Question

Using LM5069 device, in case of start-up, it seems that FET-G doesn't operate normally, As the result, LM5069 can't output voltage. Especially, FET-G occurs spike voltage. (Red circle)

<Wave form>

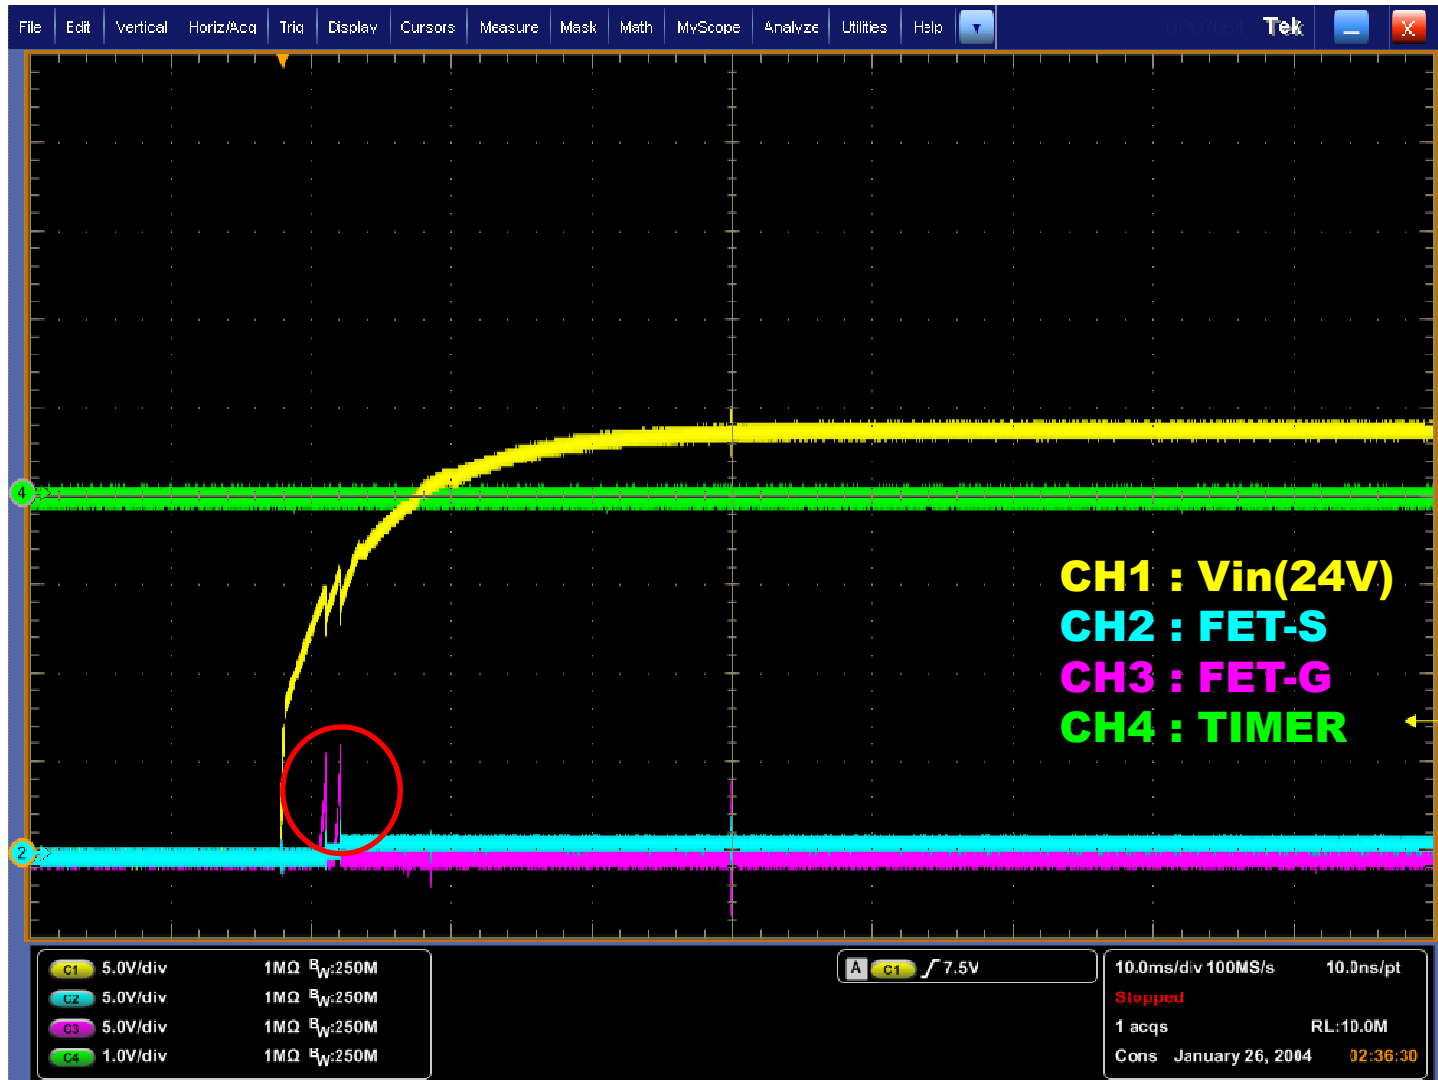
If you some advice, could you let us know? (For example, the constant of TIMER,,,))
